**CITY PLAN COMMISSION****THURSDAY, NOVEMBER 3, 2022****FILE NUMBER:** S212-077R**SENIOR PLANNER:** Mohammad H. Bordbar**LOCATION:** Ross Avenue at Carroll Avenue, west corner**DATE FILED:** October 7, 2022**ZONING:** PD 298 (Subarea 4)**PD LINK:** <http://www.dallascityattorney.com/51P/Articles/PDF/Article%20298.pdf>**CITY COUNCIL DISTRICT:** 2**SIZE OF REQUEST:** 0.79-acre**MAPSCO:** 45D**OWNER:** Rock & Ross, LLC

**REQUEST:** An application to replat a 0.79-acre tract of land containing part of Lots 1, 2, and 3 in City Block 1/650 to create one 4,987 square foot and one 29,440 square foot lot on property located on Ross Avenue at Carroll Avenue, west corner.

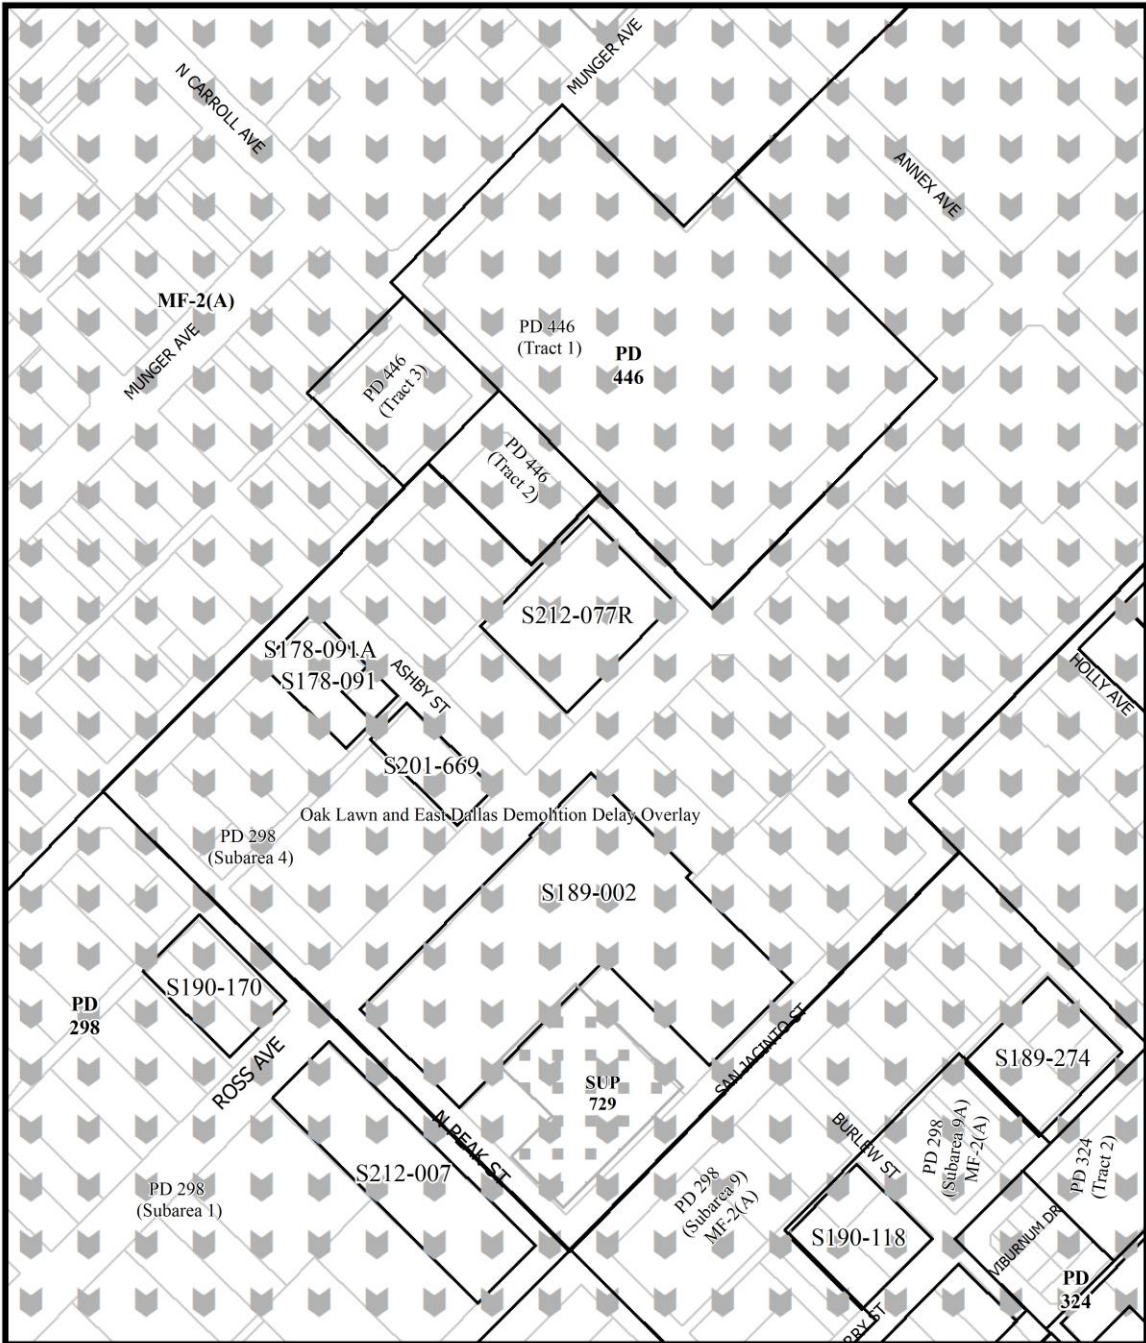
15. On the final plat, dedicate a minimum 5-foot by 5-foot corner clip (via fee simple or Street easement) at the intersection of Carroll Avenue and Ross Avenue. Section 51A 8.602(d)(1).
16. A larger corner clip may be requested during engineering plan and traffic review to accommodate an adequate turning radius, or to maintain public/traffic appurtenances with the area of corner clip. Section 51A 8.602(d)(1).
17. On the final plat, dedicate a 15-foot by 15-foot Alley Sight Easement at the intersection of Carroll Avenue & the alley. Section 51A-8.602(e)

18. Comply with Mill Creek drainage requirements. Finish floor elevation must be 3' above nearest inlet, top of curb. 51A 8.611(d), C.9 of Mill Creek, Master Drainage Plan Study

19. Prior to final plat, submit a completed final plat checklist and all supporting documents.
20. On the final plat, show how all adjoining right-of-way was created.
21. On the final plat, show distances/width across all adjoining right-of-way.

22. On the final plat, show recording information on all existing easements within 150 feet of property.
23. On the final plat, show all additions or tracts of land within 150 feet of property with recording information.

24. Additional design information is required for assessment. Site plan must be submitted showing proposed development, building finished floor elevation, development, existing mains – including downstream manhole, and proposed water and wastewater service locations. Submit water/wastewater engineering plans to 320 E. Jefferson Blvd., Room 200, Attention: Water and Wastewater Engineering.
25. Water and wastewater main improvements may be required by Private Development Contract. Submit water/wastewater engineering plans to 320 E. Jefferson Blvd., Room 200, Attention: Water and Wastewater Engineering.

26. On the final plat, change “Roseland Avenue” to “Roseland Avenue (F.K.A. Flora Street) per Vol. 13 Pg. 347. Section 51A-8.403(a)(1)(A)(xii)
27. On the final plat, change “Ashby Street” to “Ashby Street (F.K.A. Milk Street)” per Vol. 11 Pg. 265. Section 51A-8.403(a)(1)(A)(xii)
28. On the final plat, identify the property as Lots 1A and 3A in City Block 1/650. Ordinance 1A, Page 131 pages 131-148, Section 2 (passed August 13, 1872).
